Service Bulletin

Bulletin No.: 24-NA-238

Subject: Missing Circuits for Trailer Brake Lighting

Brand:	Model:	Model Year:		VIN:		Engine:	Transmission:
		from	to	from	to		
Cadillac	LYRIQ	2024	2024	-	-	S76	All

6755005

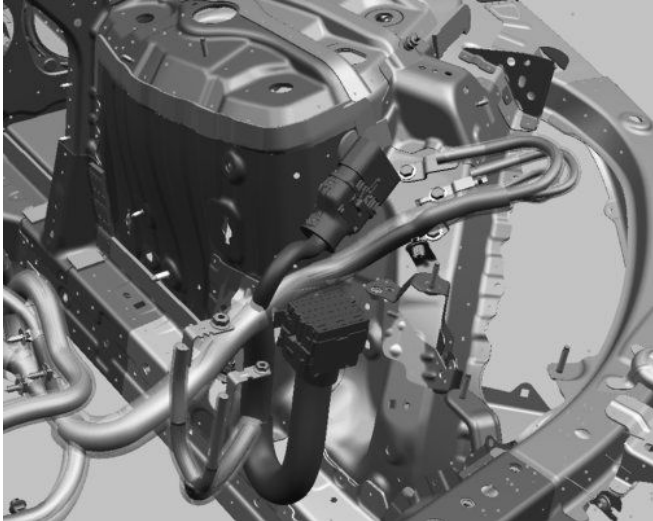
Highlighted in red is the wire routing. The 2 circuits go between these two connectors.

The circuits are only missing on the engine harness. Only circuits 7055 and 2109 need to be added to the engine harness from connector 13530982 (front inline to body) to the UEC connector.

Technician will need to use two sealed terminated-leads (refer to eSI for correct terminated lead), spliced in the center (resulting in one wire with leads on each end) for each circuit.

7055: Inline 13530982 PIN 22 to UEC X103 PIN 11

2109: Inline 13530982 PIN 24 to UEC X103 PIN 46
